**REMARKS**

Serial No. 10/615,818  
Docket No. NEC 198130 DIV

**Annotated Marked-up Figures 5B and 12B**

Submitted with Amendment B

FIG. 5B

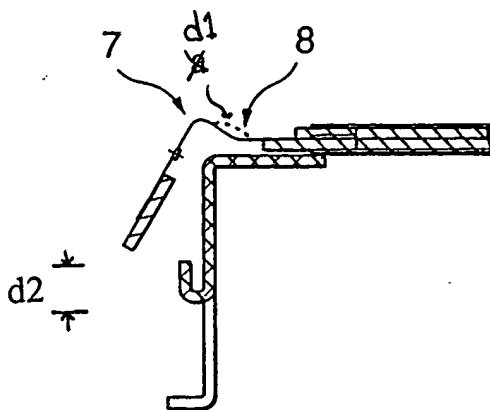
The drawing FIGS. 5B and 12B have been amended to include several reference characters.

Turning to the Examiner's objection as to the drawings, the claims, specification and FIGS. 5B and 12B have been amended accordingly. More specifically, main slit 7 and sub slit 8 are described as similar to the wide slit 10 (page 25, 4<sup>th</sup> paragraph). Also, FIG. 12B has been amended to label the main slit portion 100 and the sub slit portion 102, and to describe a distance d2 and d1, which is also depicted in amended FIG. 5B. Finally, claim 23 has been
